# WOLF CREEK

ET 96-0027

Reference: 1) Letter dated March 6, 1996, from J. C. Stone, NRC, to  
N. S. Carns, WCNOG  
2) Letter WM 95-0129, dated August 30, 1995, from  
N. S. Carns, WCNOG, to USNRC  
Subject: Docket No. 50-482: Response to Request for Additional  
Information, Second 10-Year Inservice Inspection Interval

**Response to Request for Additional Information**

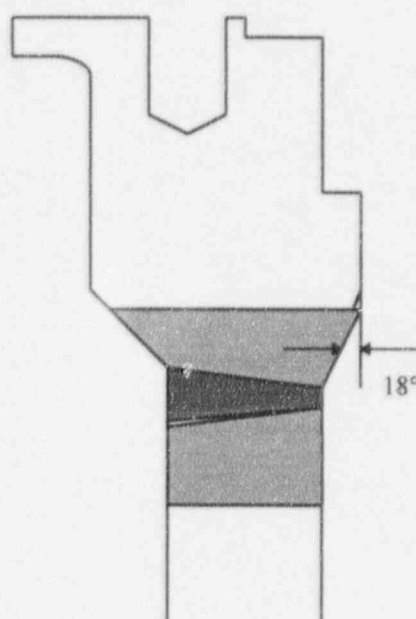
In Requests for Relief I2R-03, I2R-04, I2R-05, I2R-06, and I2R-09, which address welds that have received partial ultrasonic examinations, it is unclear how the coverages were calculated. Provide detailed information on how the coverage was determined, including the cumulative coverage for each examination area. Also provide a detailed drawing of each examination area depicting all limitations.

I2R-03: The information provided was the same as that provided for the first 10-year interval. However, this component's second interval examination (automated portion only) had been performed during Refueling Outage 8 in the Spring of 1996 and new coverage percentages were obtained. Figure 1 represents a drawing (not to scale) of the Flange to Upper Reactor Vessel Shell Weld and the applicable beam directions/angles are listed with the appropriate examination coverages.

The manual examination portion from the flange surface was 90% complete for the first 10-year interval and is therefore expected to be the same for the second interval. The amount of coverage for weld metal (WM) interrogation is shown as a separate value to identify the amount of coverage in the volume where a crack would have a higher probability of presence.

**Figure 1**  
**RV-101-121 Scan Limitations**  
(I2R-03)

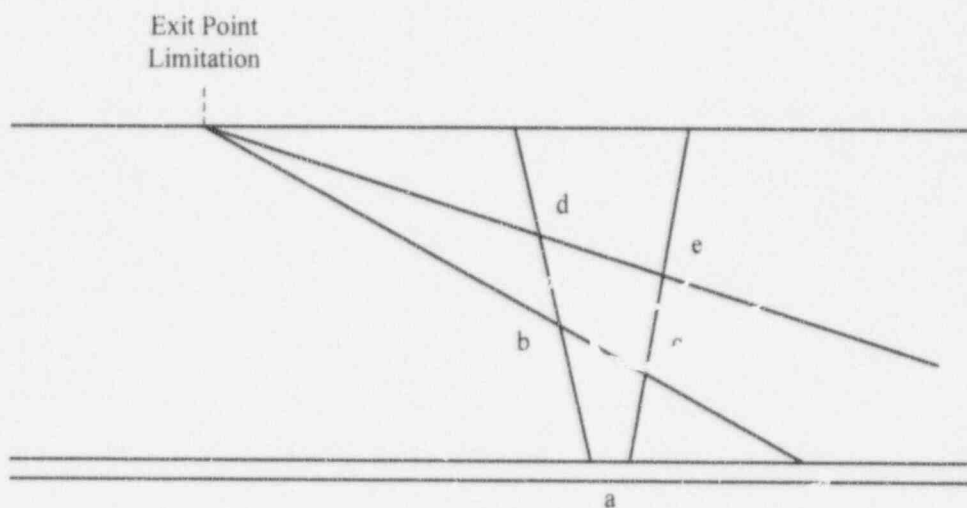
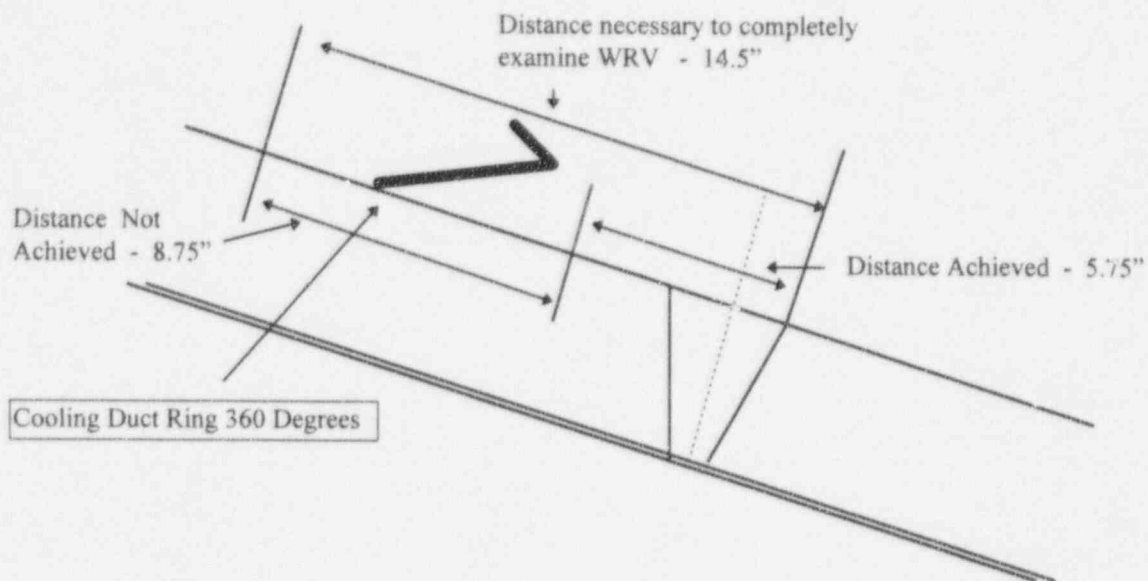
In addition to the above relief requests, the NRC contract reviewers had requested, during the telecon on April 24, 1996, coverage percentage information for Relief Request I2R-18. This too included the same information as the approved relief request contained for the first 10-year interval. These are Reactor Coolant System branch connection components that allowed only a single sided examination (pipe side only). Coverage of 100% was achieved from the one side and of both directions on the parallel scan (composite coverage of 75%). However, because of material properties as discussed in the relief request, the examiners were unable to accomplish an extended beam path to examine from the opposing direction.

abc represents portion of weld not examined  
in two directions by  $45^\circ = 16.8\%$

ade represents portion of weld not examined  
in two directions by  $60^\circ = 47.3\%$
